**Officer South Employment Precinct Structure Plan
Draft Amendment C274card**

Victorian Planning Authority Projects Standing Advisory Committee Referral 8 Report

Officer South Employment Precinct Structure Plan

Draft Amendment C274card

Figure 6 'Day 2' Staging Plan

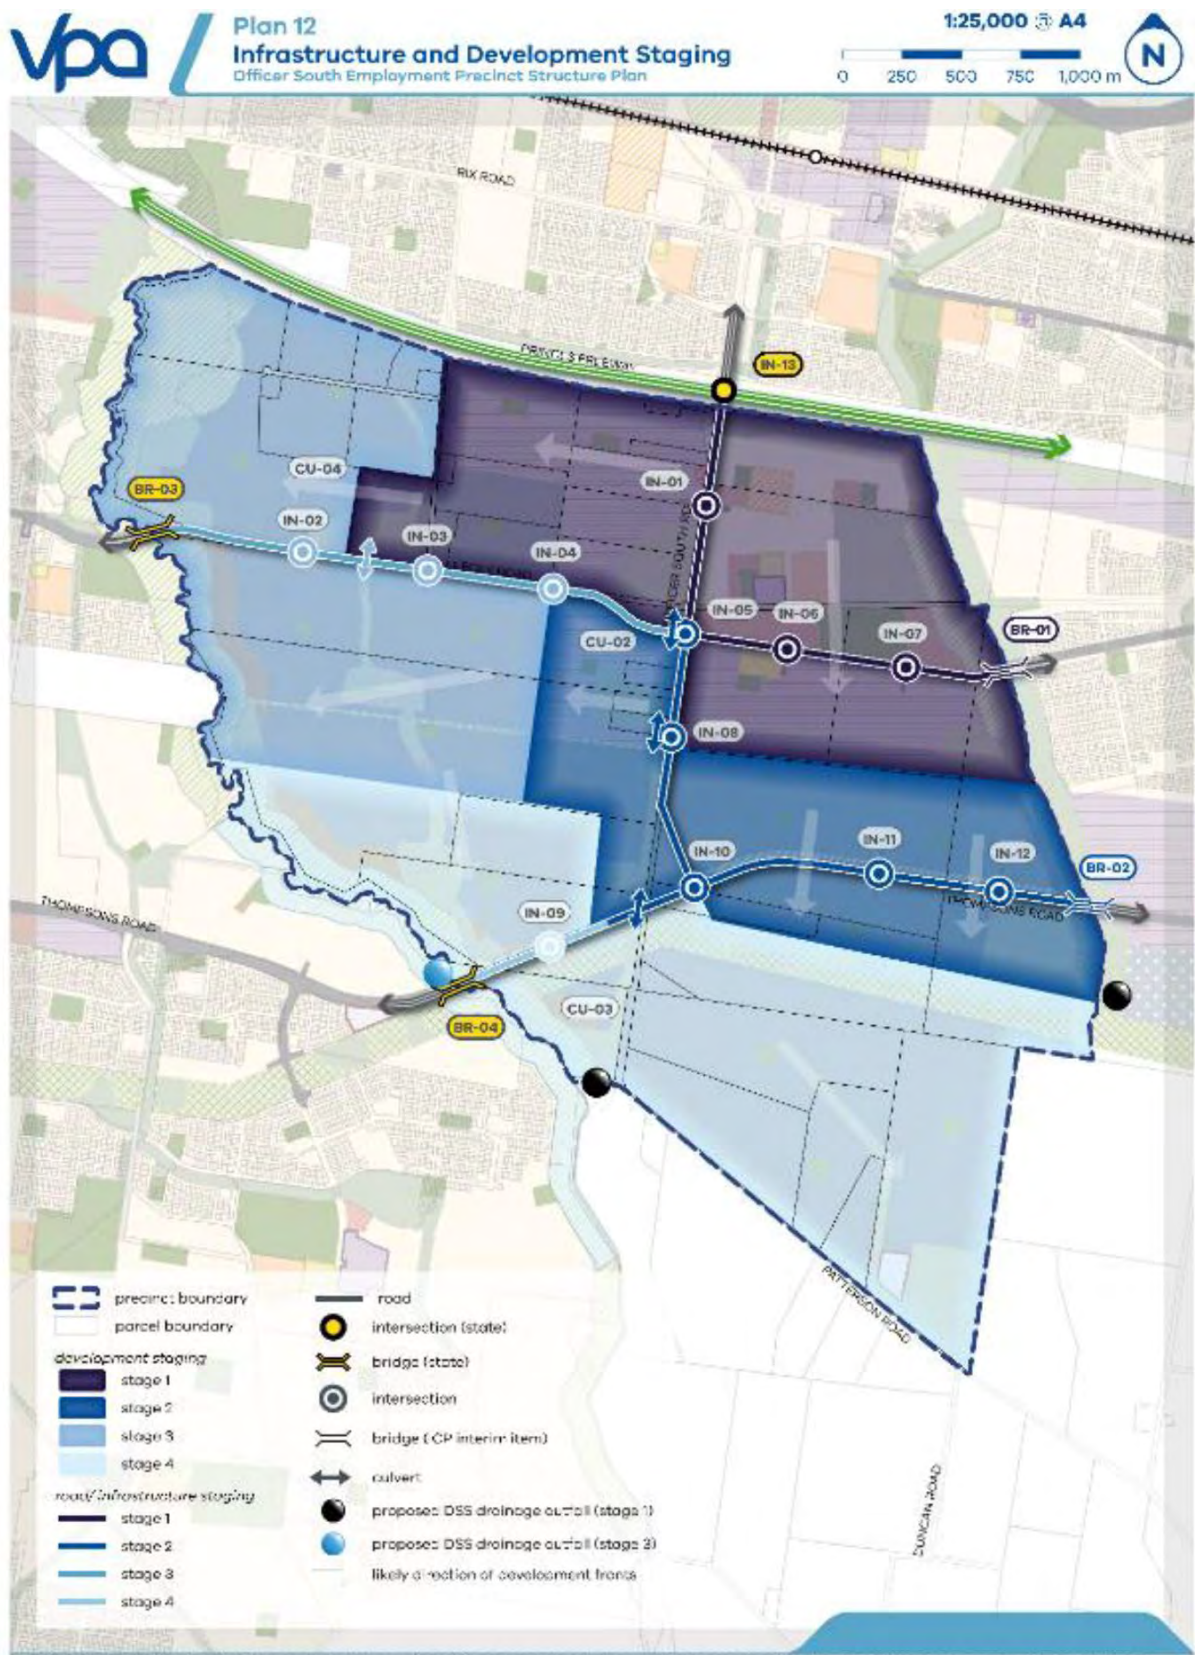
- l) If Plan 12 (Infrastructure and Development Staging) is to be retained in the Precinct Structure Plan, amend Plan 12 by:
- removing intersections IN-01 to IN-12, or

- alternatively, removing the colour coded depiction of the intersections which matches them to the proposed stages.
- m) If, contrary to the previous Recommendation, intersections are to remain on Plan 12 and linked to a particular stage of development:

- amend Plan 12 to show the whole of intersection IN-05 linked to Stage 1
 - include provisions in either the Precinct Structure Plan or the Urban Growth Zone Schedule 7 to require intersection IN-05 to be delivered in Stage 1.

Figure 8 PSP Plan 9 (Integrated Water Management)

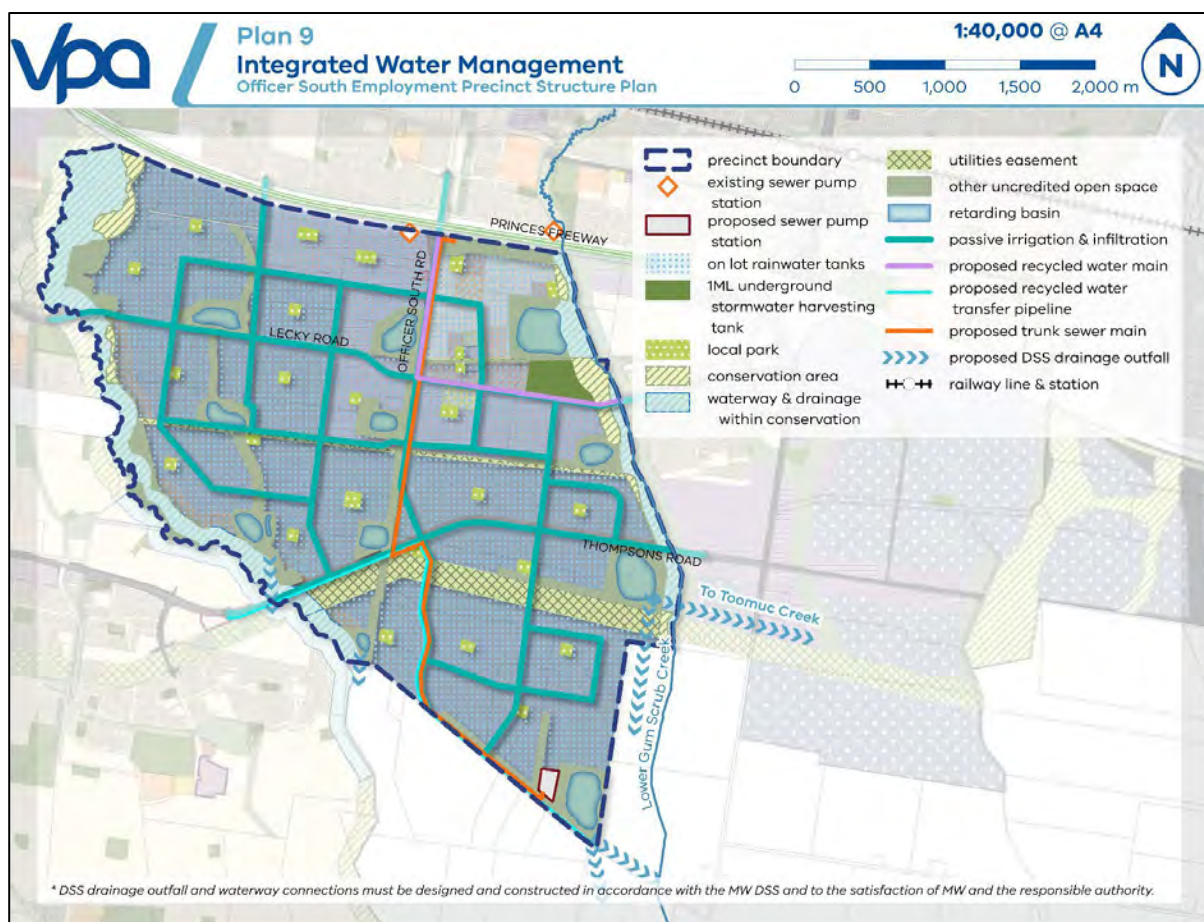
- g) Rewrite Guideline G74, relating to the high pressure gas pipeline easement, to clarify its meaning and intent.
 - h) Amend Requirement R31 and the text under Plan 9 (Integrated Water Management) to strengthen the notion that flexibility should be applied when considering whether changes to the size or location of drainage assets are 'generally in accordance with' the Precinct Structure Plan.

- i) Amend Plan 9 (Integrated Water Management) to:
- Remove the Stephens Road waterway. Retain the waterway on other plans only if there are other reasons (for example high value tree retention) which justify its retention.
 - Include some supporting text encouraging the implementation of the relevant Integrated Water Management initiatives in each 'pilot area'. This could be a note on Plan 9, or a Requirement or a Guideline in the appropriate section of the Precinct Structure Plan.
 - Remove references to Class A recycled water in pilot areas 1 and 3 if the use of recycled water would compromise the potential benefits of stormwater harvesting in reducing the total volume of stormwater in the system.
 - Correct the boundaries of pilot area 4 if required.

Plan 2
Precinct Features
Officer South Employment Precinct Structure Plan

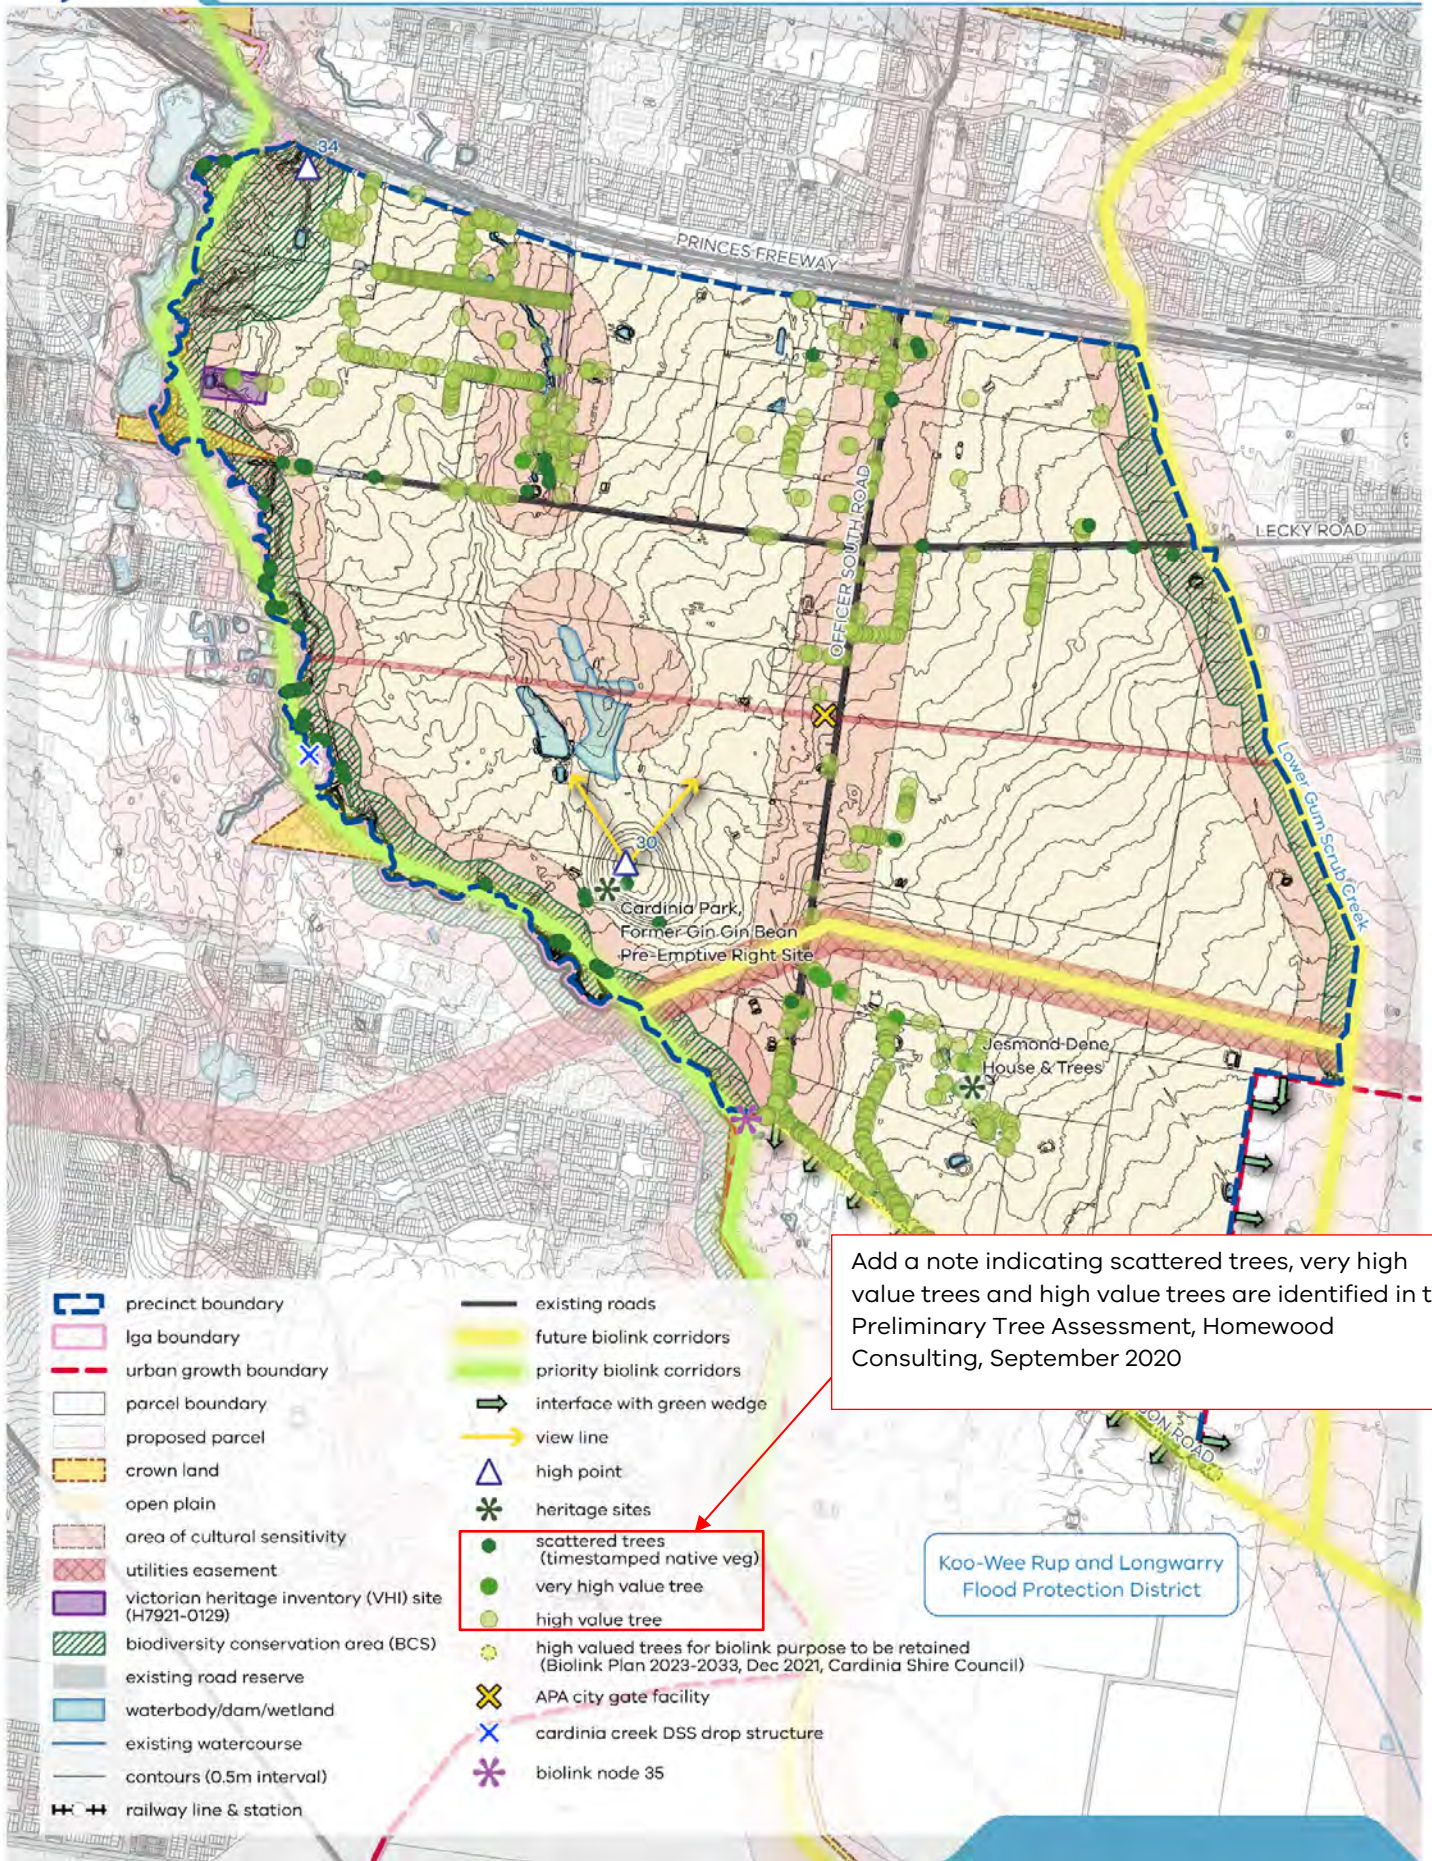
Add a note indicating scattered trees, very high value trees and high value trees are identified in the Preliminary Tree Assessment, Homewood Consulting, September 2020

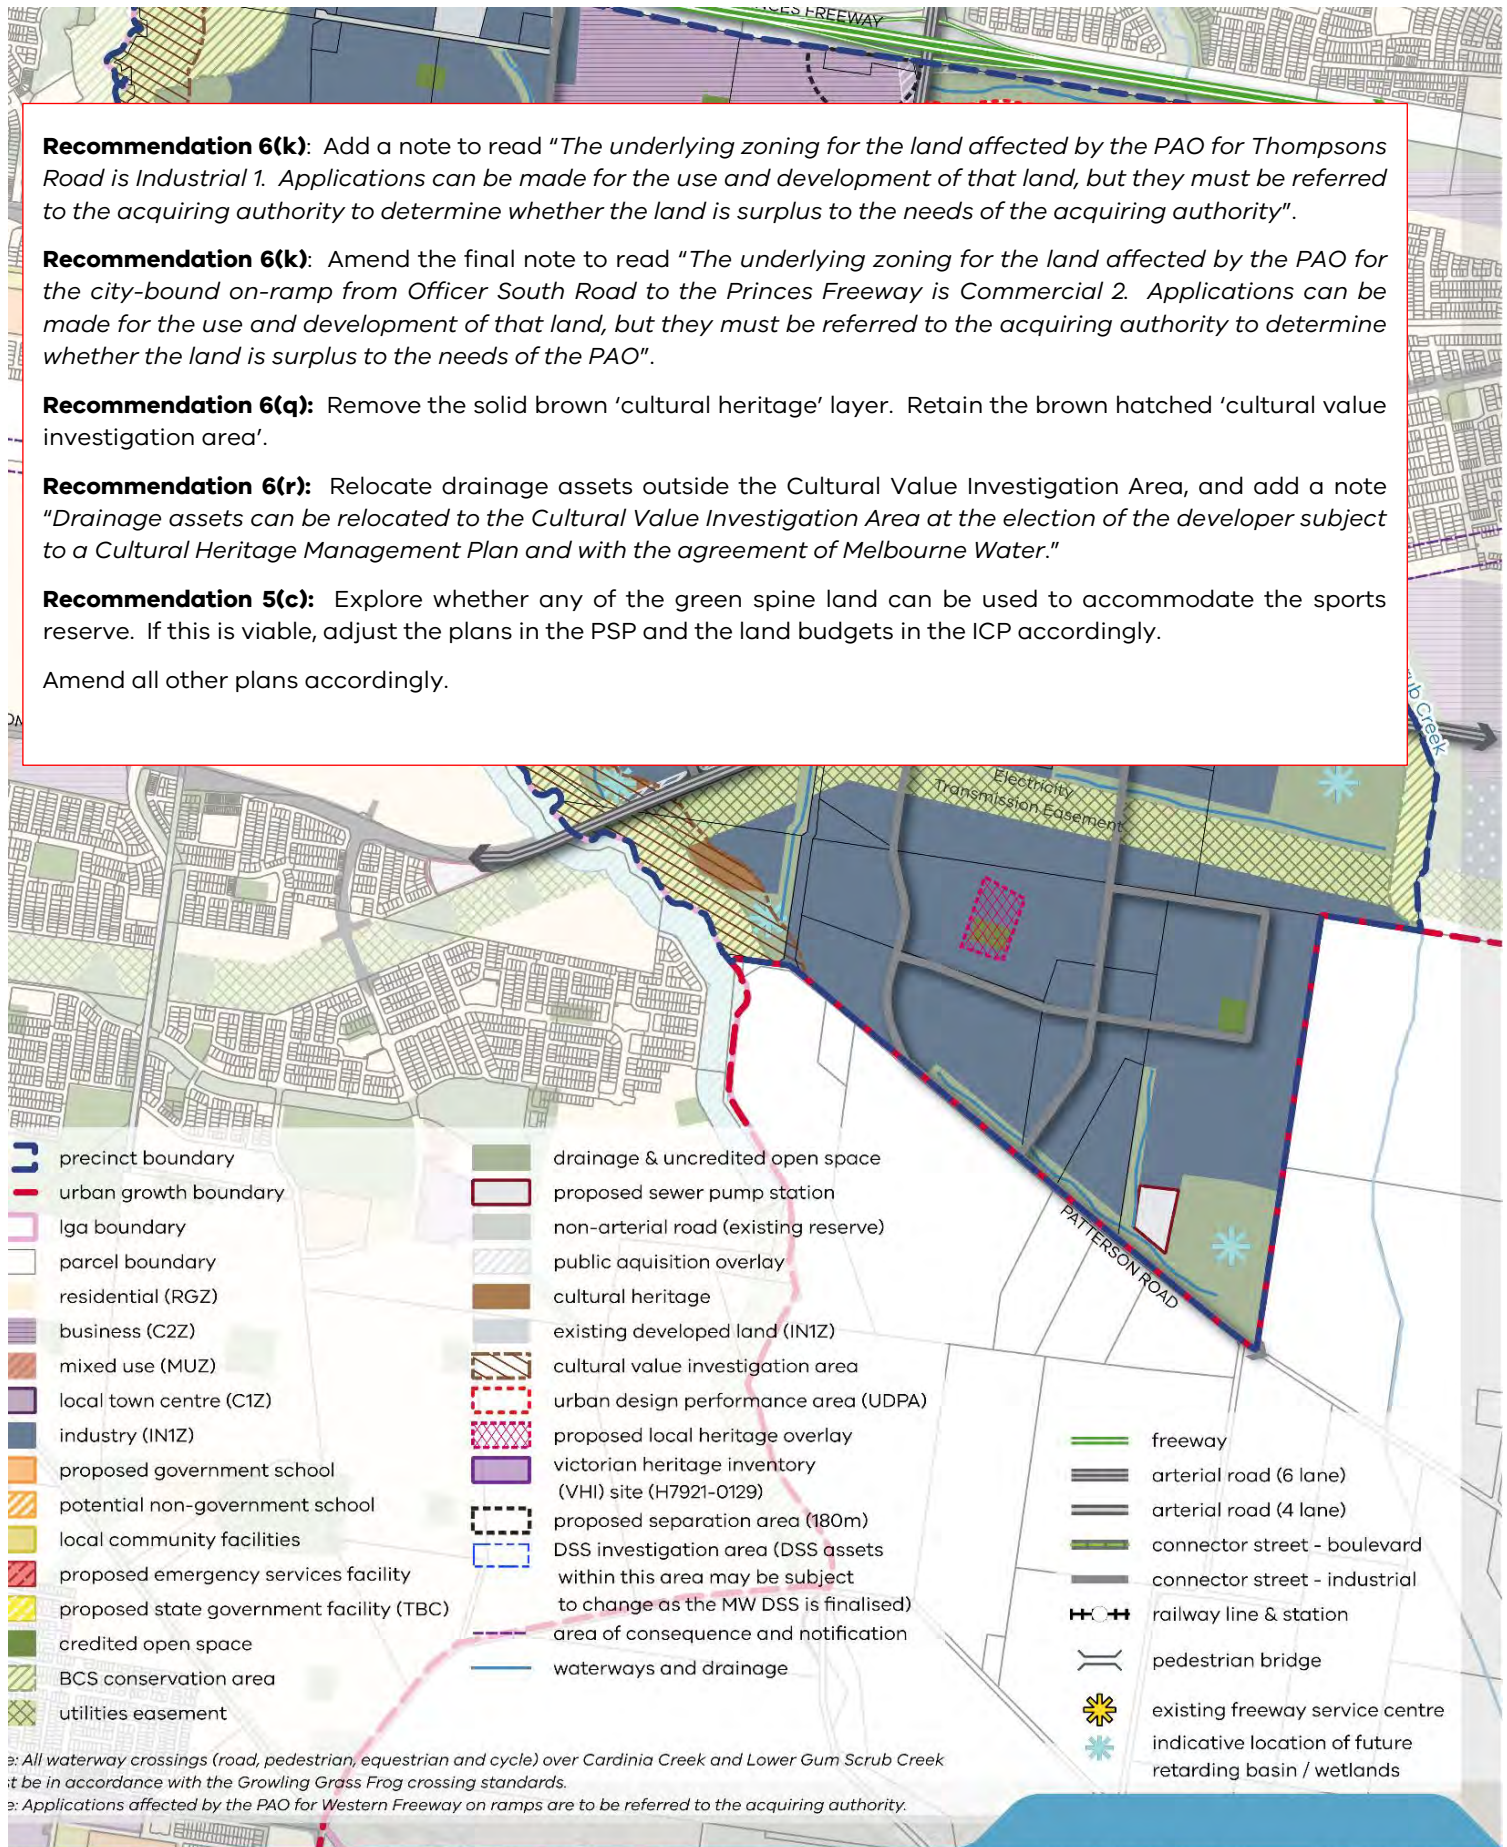
Recommendation 6(k): Add a note to read "The underlying zoning for the land affected by the PAO for Thompsons Road is Industrial 1. Applications can be made for the use and development of that land, but they must be referred to the acquiring authority to determine whether the land is surplus to the needs of the acquiring authority".

Recommendation 6(k): Amend the final note to read "The underlying zoning for the land affected by the PAO for the city-bound on-ramp from Officer South Road to the Princes Freeway is Commercial 2. Applications can be made for the use and development of that land, but they must be referred to the acquiring authority to determine whether the land is surplus to the needs of the PAO".

Recommendation 6(q): Remove the solid brown 'cultural heritage' layer. Retain the brown hatched 'cultural value investigation area'.

Figure 7 – Power Easement Concept
Officer South Employment Precinct Structure Plan

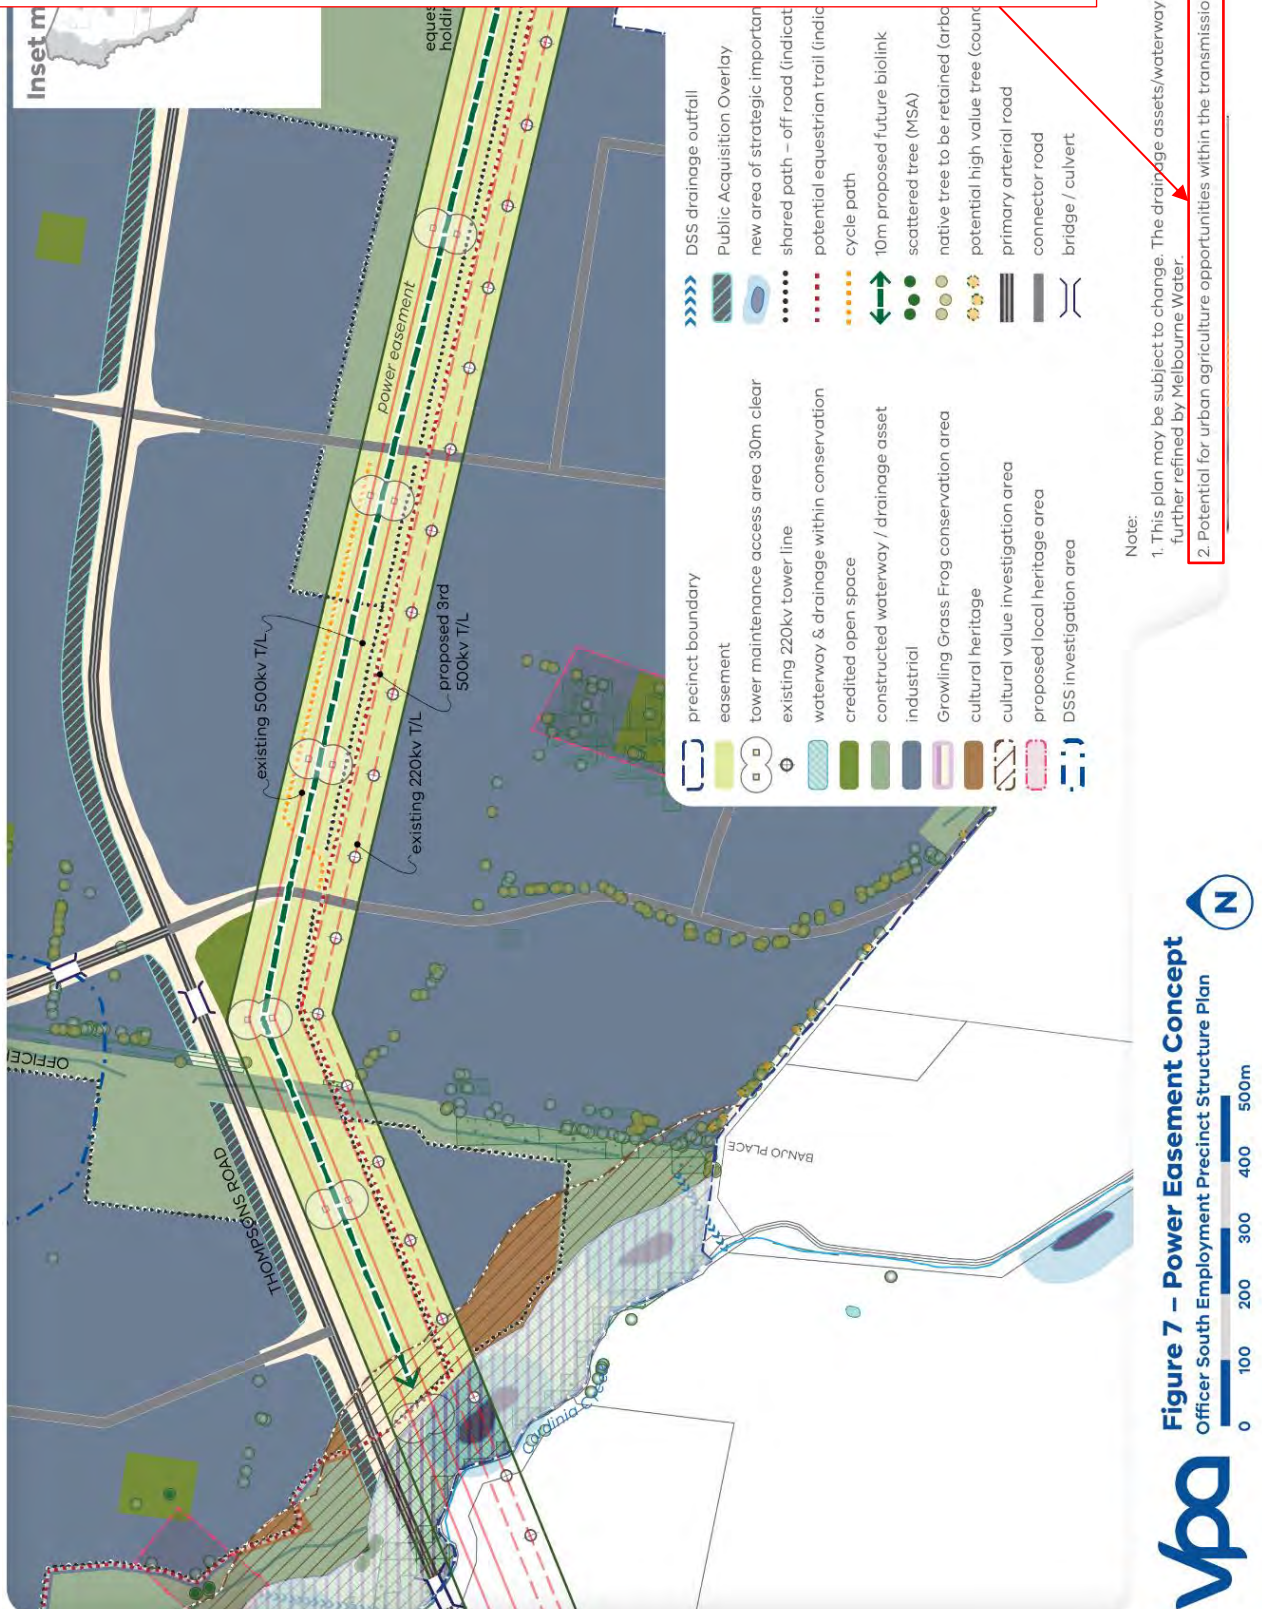
Consider adding a note to the effect that Cardinia Shire Council be required to demonstrate the equestrian trails are deliverable to the satisfaction DTP/TfV (see Chapter 5.8)
